**PHILLIPS 66 PROPANE RECOVERY PROJECT**  
**Recirculated Final Environmental Impact Report**  
**SCH No. 2012072046**  
**County File No. LP12-2073**

**Contra Costa County**  
**Department of Conservation**  
**and Development**

**January 2015**

## Phillips 66 Propane Recovery Project Recirculated Final Environmental Impact Report (Response to Comments)

Figure 1. Total Central Coast OCS, offshore, and onshore oil production of fields supplying crude oil to the Phillips 66 SMF from 1995–2012, and forecast to 2050.

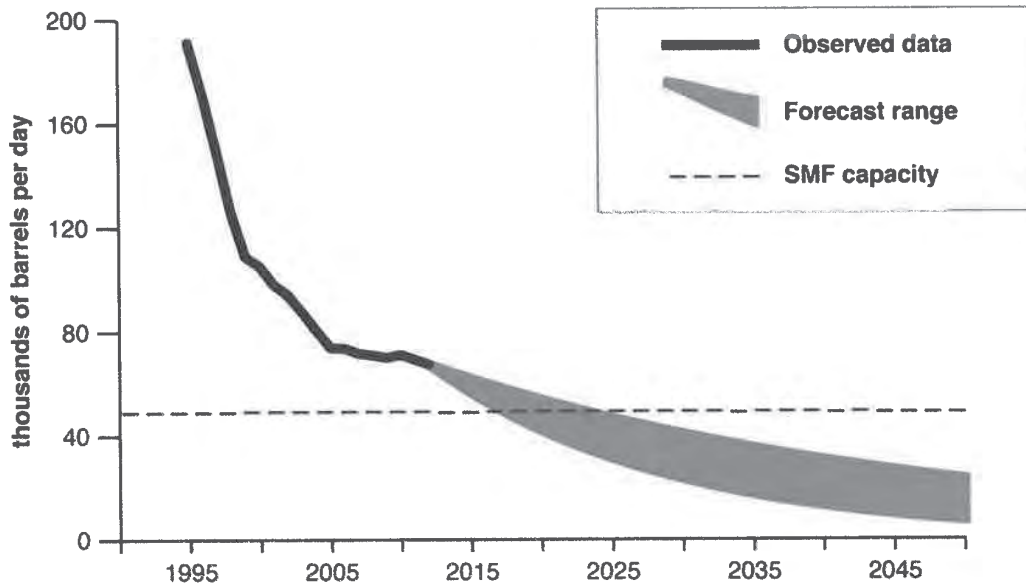
21. If built as proposed the project would be expected to have a useful operational duration of 30–50 years (until 2045–2065).<sup>30</sup> As shown in paragraph 20 and Figure 1, current crude sources supplying project feedstock would dwindle during this period.

34. In the ‘No SMF projects’ scenario, SMF crude throughput would rely on terminally declining local/regional crude supplies and would decline as illustrated in Figure 1. A conservative (less steep) estimate of this decline and its effects on processing is described in Table 1 (see caption), for the time frame roughly around 2045, which is within the project duration (see paragraph 21). SMF-to-RF naphtha and gas oil volumes drop by about half and *total* RF gas oil hydrocracking drops by ≈21%. This is a conservative estimate; if it does not replace its already-declining crude feedstock supply by then, the SMF might more likely be shut down by 2045. (See Figure 1.)

- B9-76 See Master Response 2.4.
- B9-77 See Master Response 2.4.
- B9-78 See Master Responses 2.2 and 2.4.
- B9-79 See Master Responses 2.2 and 2.4. The commenter claims that the RDEIR has “re-routed” naphtha streams from U246 and U250 to naphtha blending. However, Figure 3-6 in both the 2013 DEIR and RDEIR both indicate these naphtha streams are routed to naphtha blending. Therefore, there is no change required in the proposed project description.

Phillips 66 Propane Recovery Project, 120546  
**Figure 3-6 Revised**  
 Proposed Refinery Fuel Gas System Block Flow Diagram

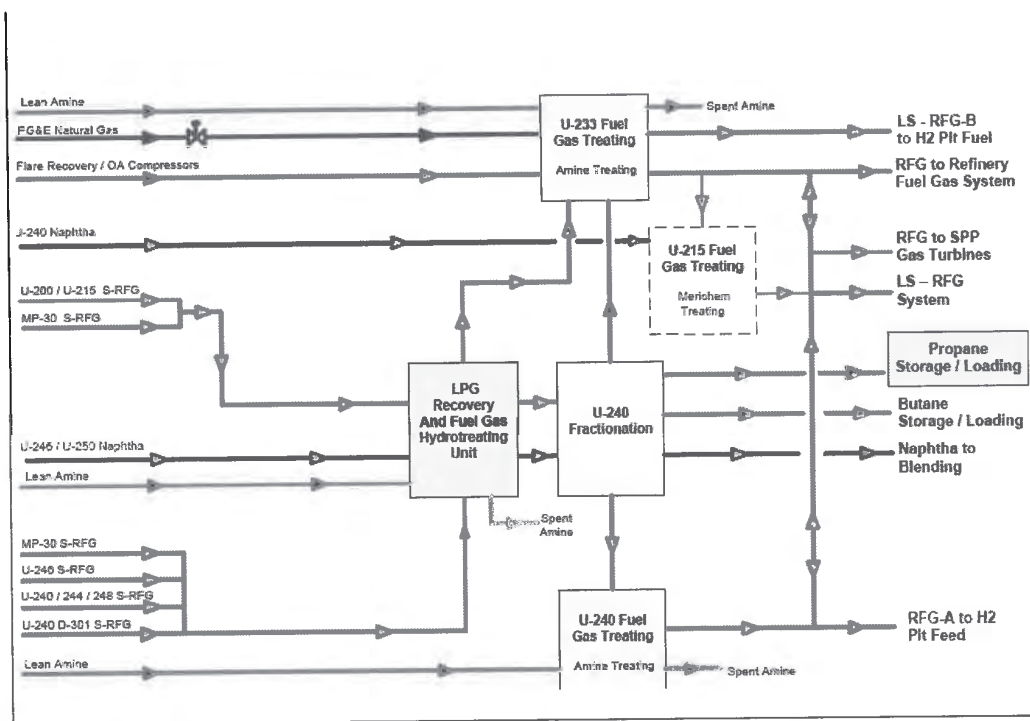
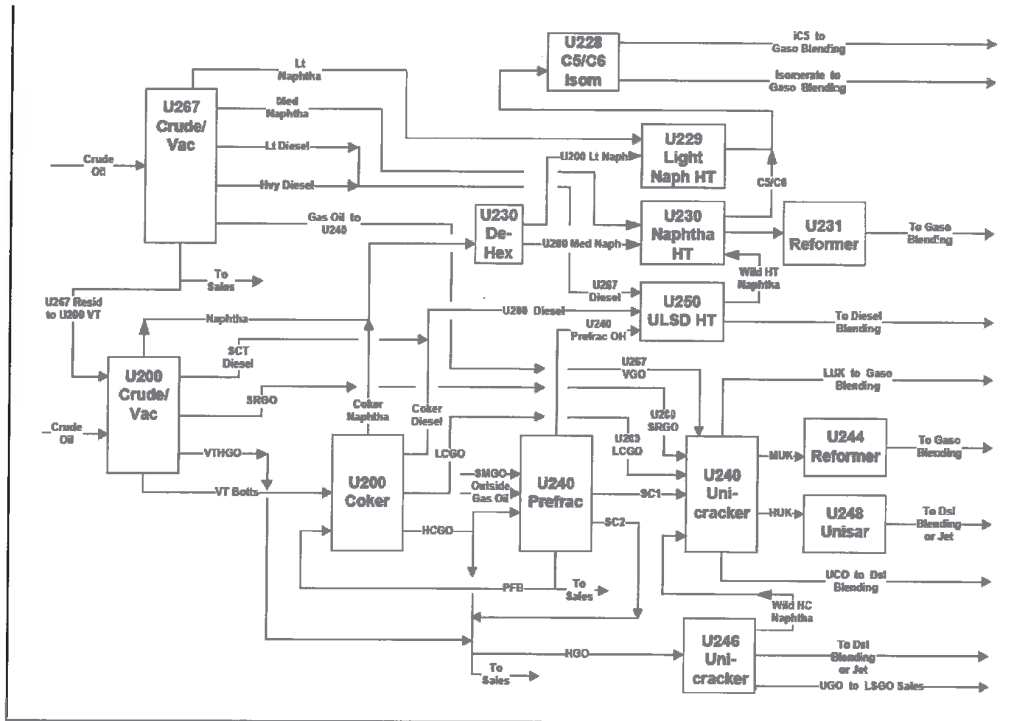
9. Sources of the LPG to be recovered, as described in the DEIR, did *not* include several streams feeding ‘RFG-A.’ (DEIR Figure 3-6.) These ‘RFG-A’ streams are now included among those from which LPG could be recovered. (RDEIR Figure 3-6.) This change in the project description reveals undisclosed changes in hydrogen plant feed and further implicates feedstock from the Santa Maria facility (see figs. 3-4, 3-6), but the RDEIR includes no discussion of any potential effects from this change in the project.

36. Importantly, an otherwise unexplained change in the project description is informed by the ‘current conditions’ and ‘SMF project’ results for naphtha in Table 1. Naphtha from the Rodeo heavy gas oil hydrocracker (Unit 246) and the ULSD diesel hydrotreater (U250) is routed through the proposed new ‘fuel gas’ hydrotreater in Revised Figure 3-6 of the RDEIR. These streams were routed through the proposed LPG recovery but *not* the proposed new hydrotreater in Figure 3-6 of the June 2013 DEIR. Further, these U246 and U250 streams are ‘wild naphtha’ derived at least in part from processing the SMF gas oil (‘SMGO;’ see Figure 3-4.<sup>51</sup>) Finally, these wild naphtha streams are now fed through other processes to reforming units U231 and U244 (see Figure 3-4), but revised Figure 3-6 shows the project re-routing them to naphtha blending instead. In sum, these naphtha streams are fed to the Rodeo reformers now but the revised LPG recovery proposal would instead route them through the new hydrotreater. For convenient review, RDEIR Revised Figure 3-6, RDEIR Figure 3-4, and original Figure 3-6 from the June 2013 DEIR are excerpted below.

- B9-50 2013 DEIR Figure 3-6 incorrectly showed that one of the RFG streams currently used to produce “RFG-A,” U240 D-301 S-RFG, would not be included among the RFG streams that would be treated for liquefied petroleum gas (LPG) removal under the proposed Project. Under the proposed Project, the U240 D-301 S-RFG stream would be included among the RFG streams that would be treated for LPG removal. This error in the 2013 DEIR was limited to the flow information illustrated in Figure 3-6, and the text description of the proposed Project and the associated environmental analyses are unaffected by this error. There have been no substantive changes to the project description subsequent to the 2013 DEIR; however, RDEIR Figure 3-6 was revised and presented in the RDEIR to include the current flow data.

- B9-52 As discussed in Response B9-50, there have been no substantive changes to the project description subsequent to the 2013 DEIR; however, RDEIR Figure 3-6 has been revised to include the current flow data.

Phillips 66 Propane Recovery Project, 120546  
 Figure 3-4  
 Overall Block Flow Diagram of Refinery

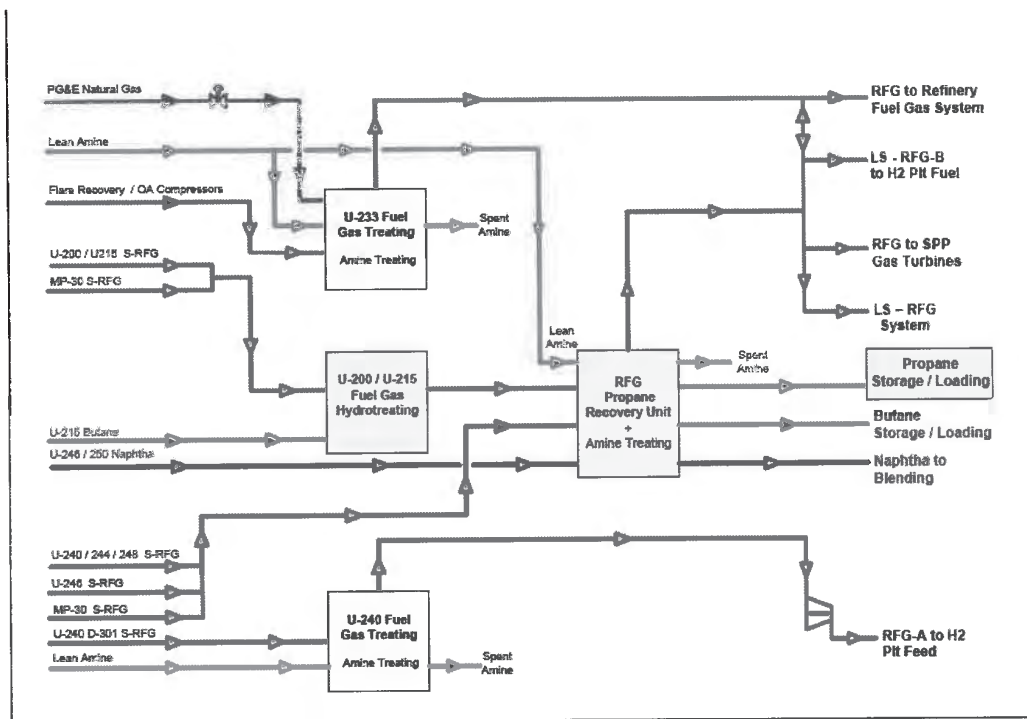
10. Additional hydrocarbon streams would be treated by the proposed new hydrotreater, but this change and its implications are not discussed in the RDEIR. Naphtha streams from the heavy gas oil hydrocracker (Unit 246) and the ULSD diesel hydrotreater (U250) are fed to reforming units U231 and U244 now, but the revised project description would instead route them through the new hydrotreater. (Compare DEIR and RDEIR figures 3-4, 3-5, and 3-6.)
